## **Response to Reviewer#1**

Interactive comment on "Hydrological and Runoff Formation Processes Based on Isotope Tracing During Ablation Period in the Third Polar Region" by Zong-Jie Li et al.

Anonymous Referee #1

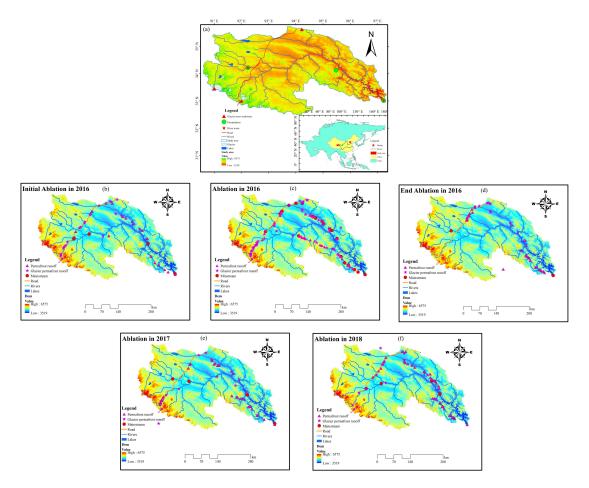
c. Fig. 1a: The red star represents river water, but there is no red star in the map.Thank you very much for your comments. Fig.1 has been revised as:

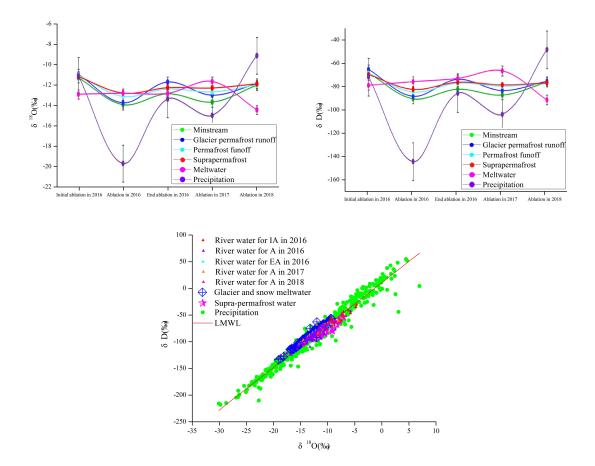
19) Fig7: Please add an error bar to represent the range of isotope in water during each period.
